ADDENDUM

Project: Grand Lake St. Mary's State Park, Park Office Renovation
Project No.: DNR-250013
Date: October 21, 2025
Addendum No.: 1

A500.1

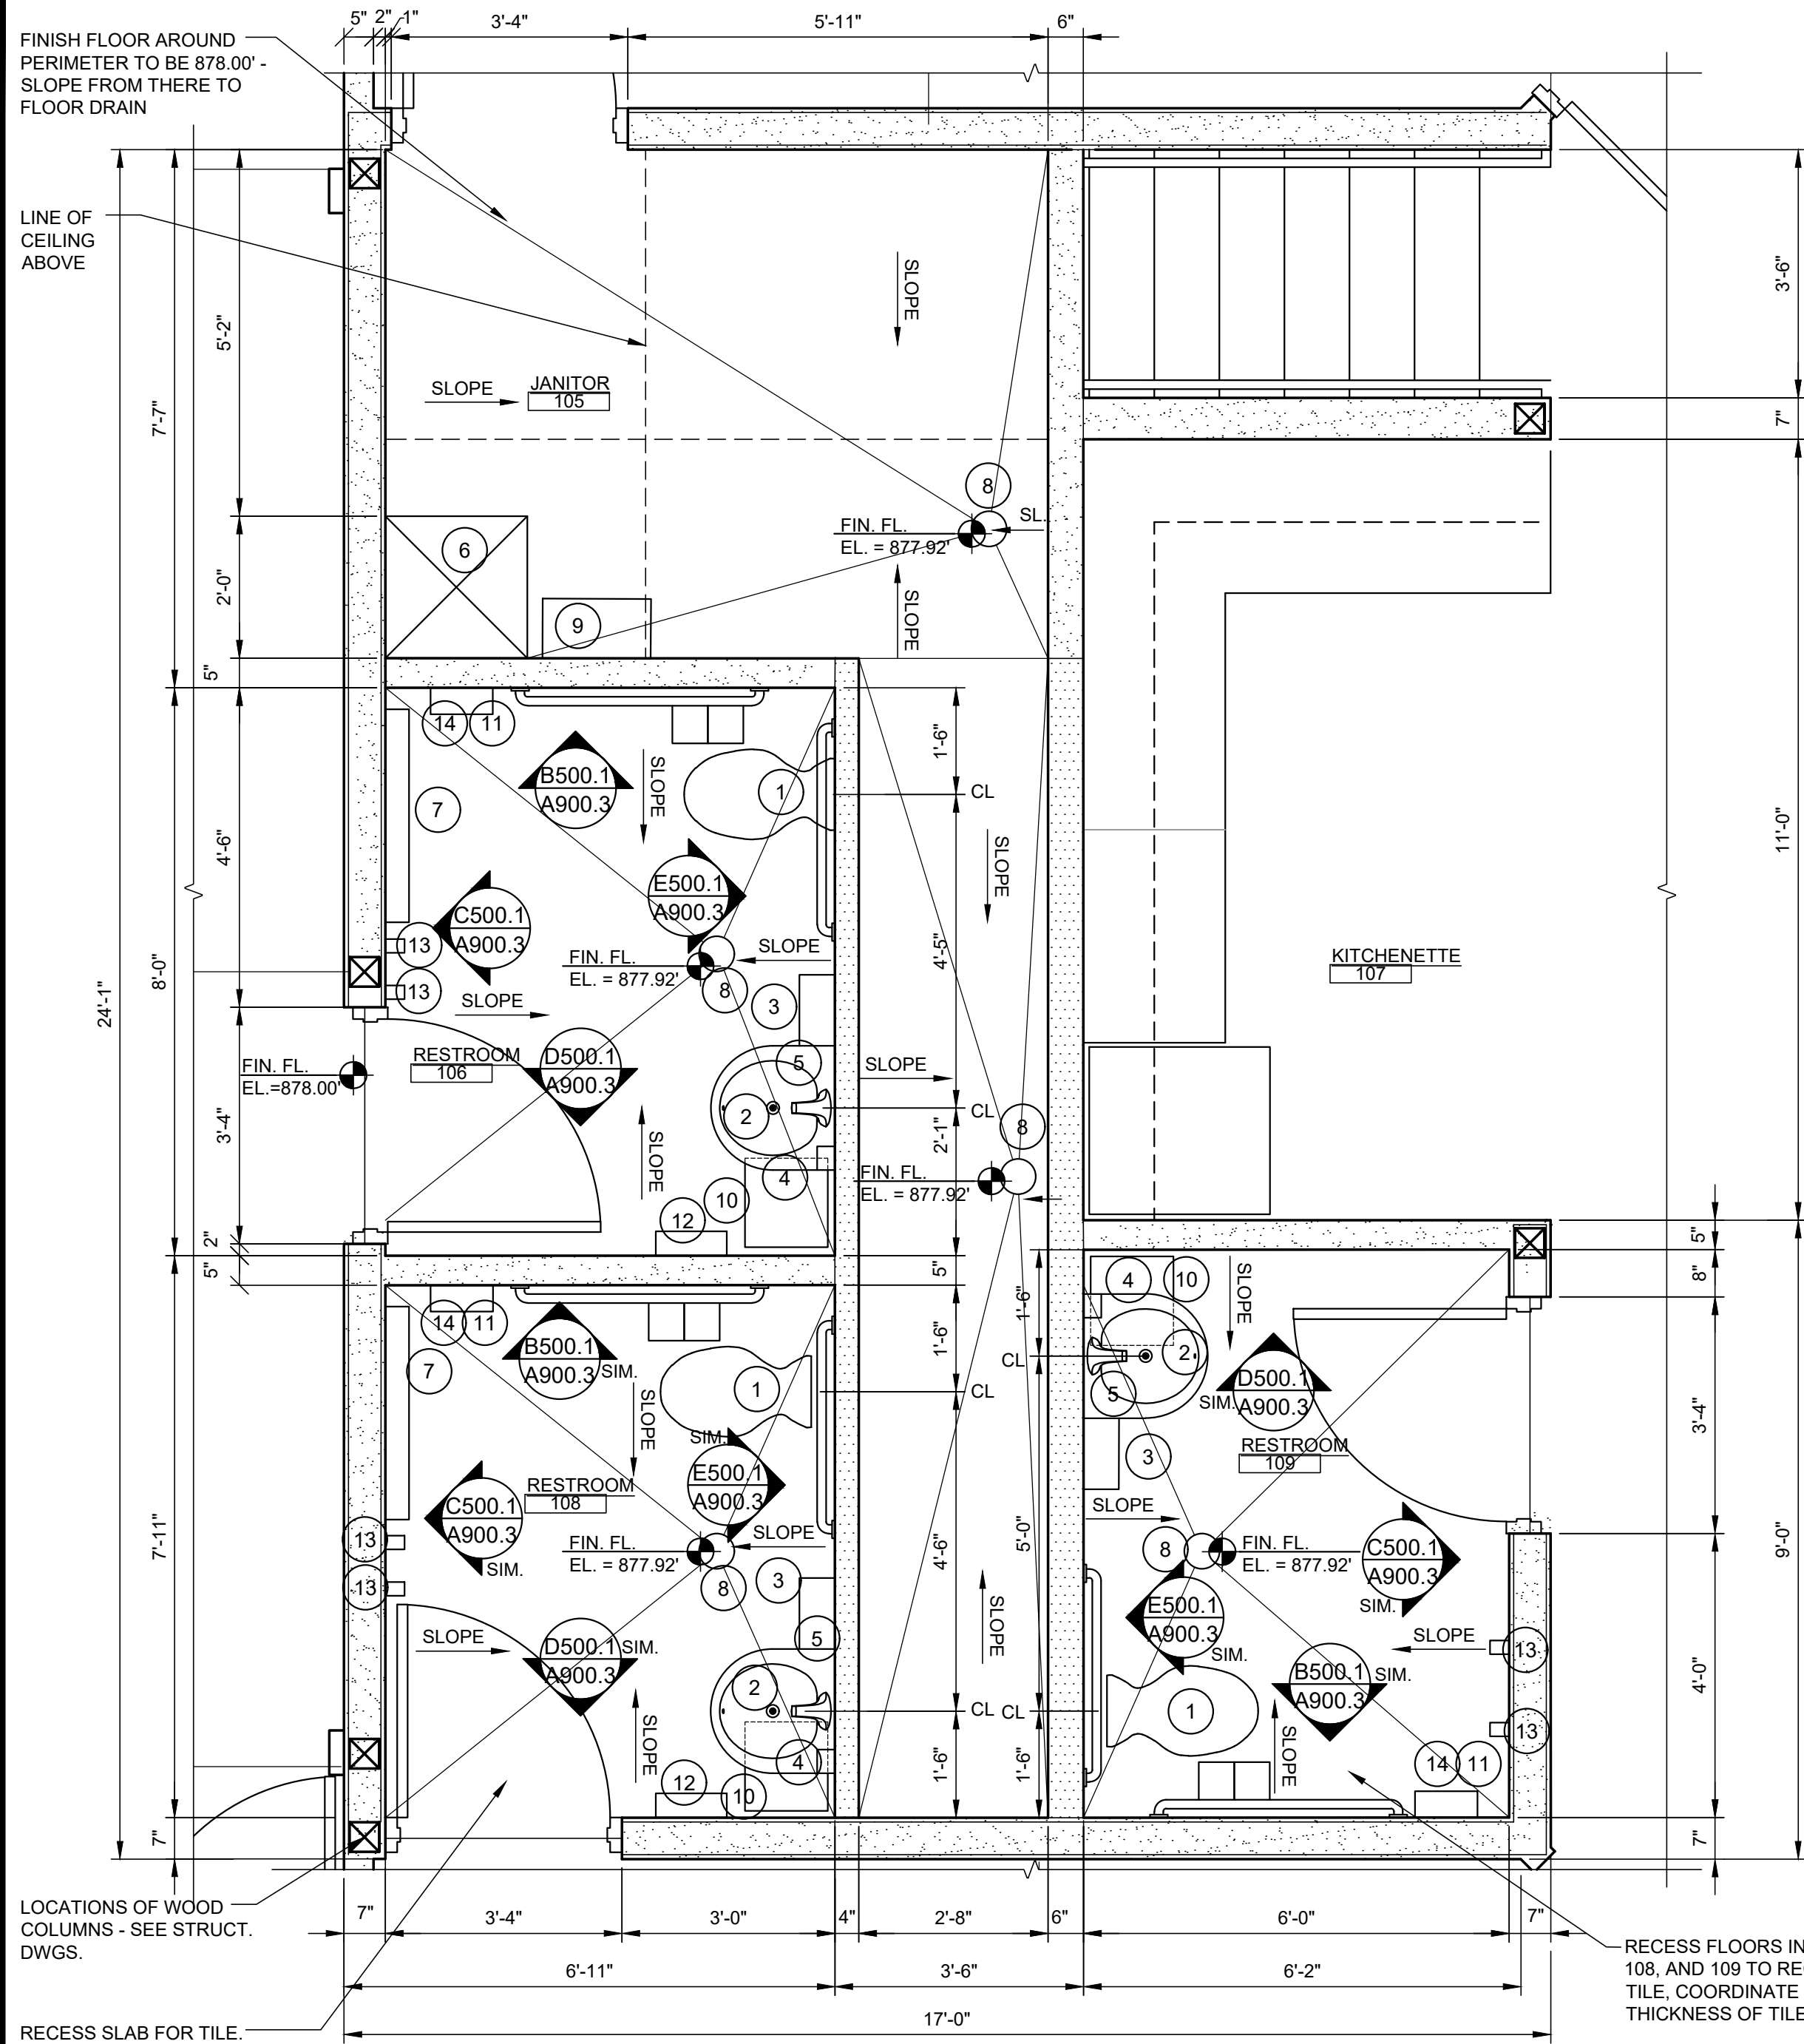
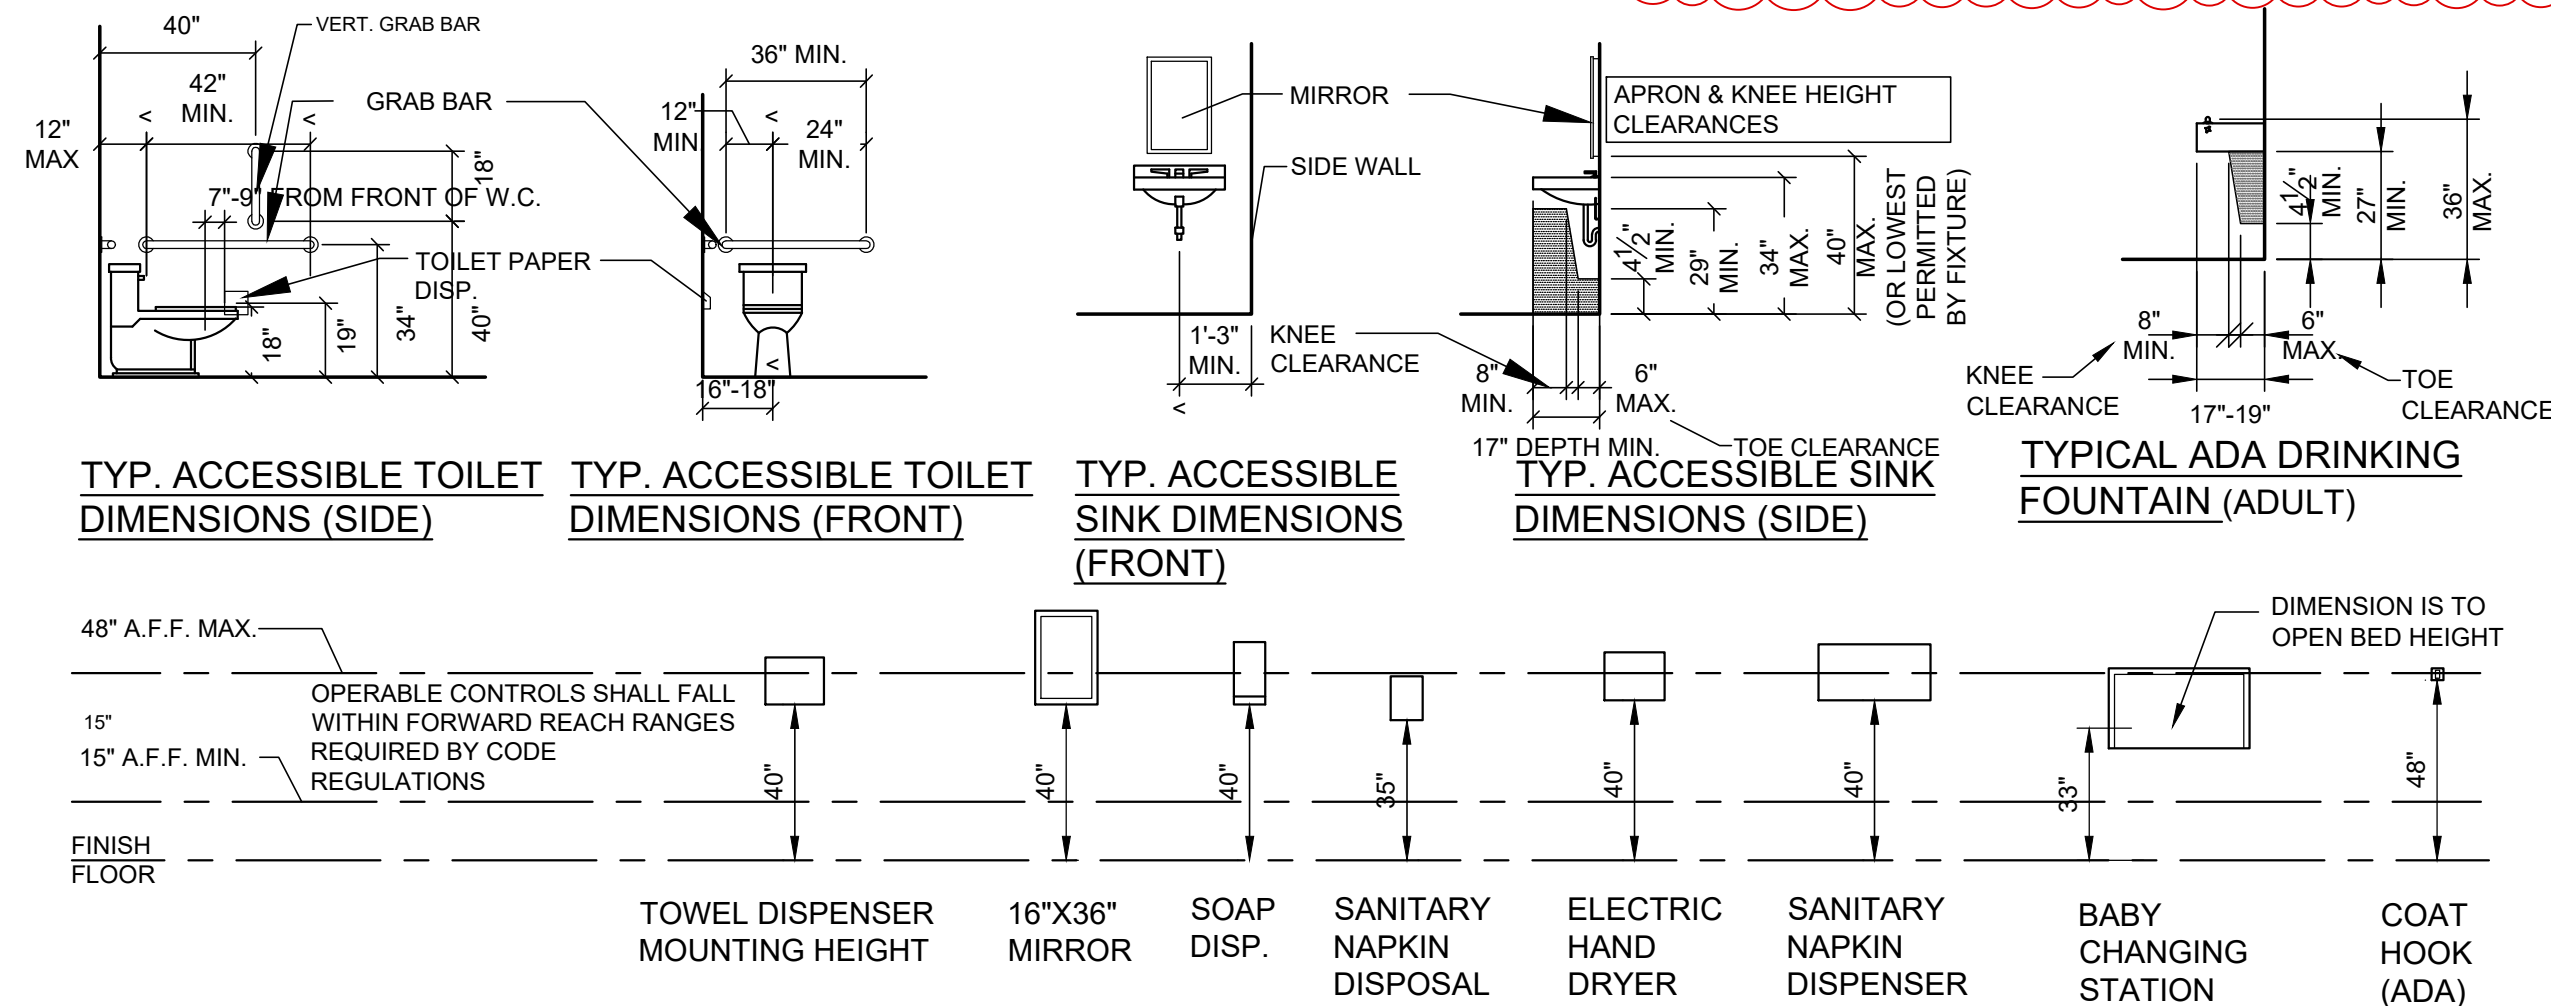
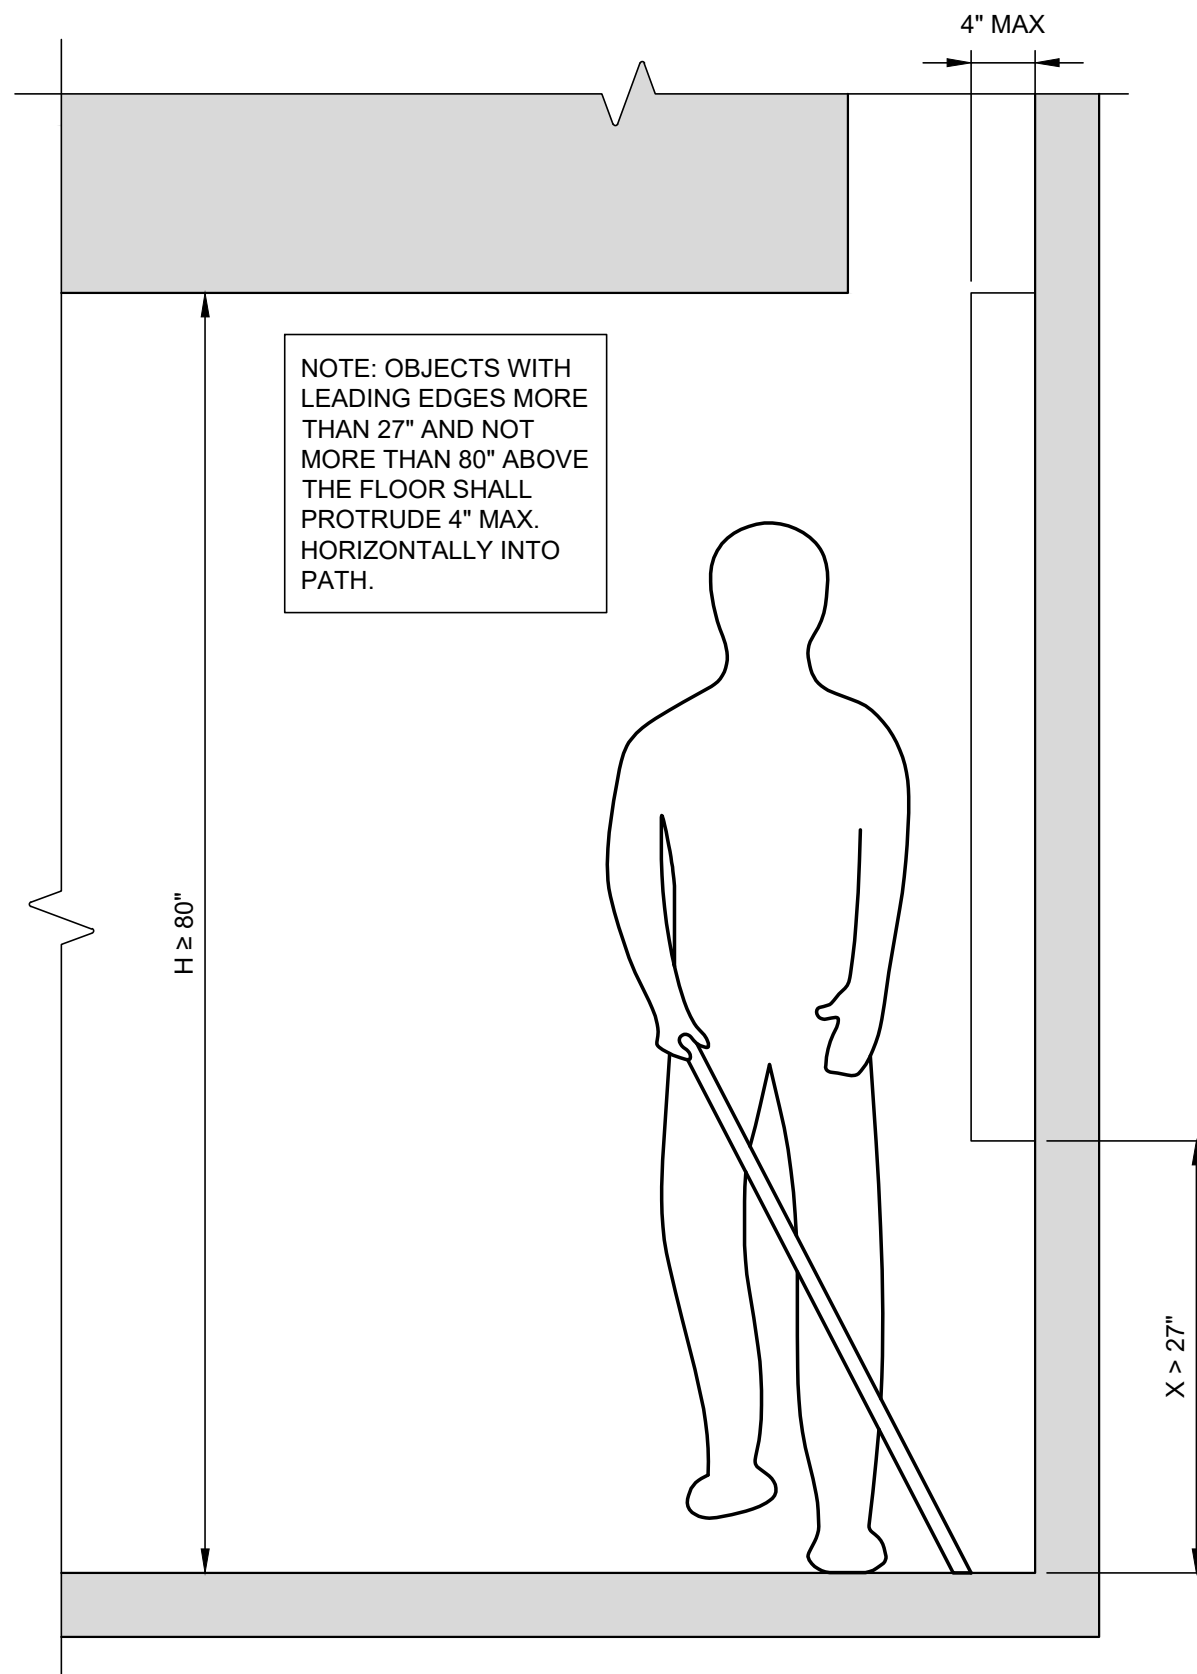
Item 8 – A500.1 (Revised)

- Before final floor finish is installed in drained areas of restrooms, floors shall be water tested / flooded to insure no puddling and positive drainage occurs before final finish coat is applied.
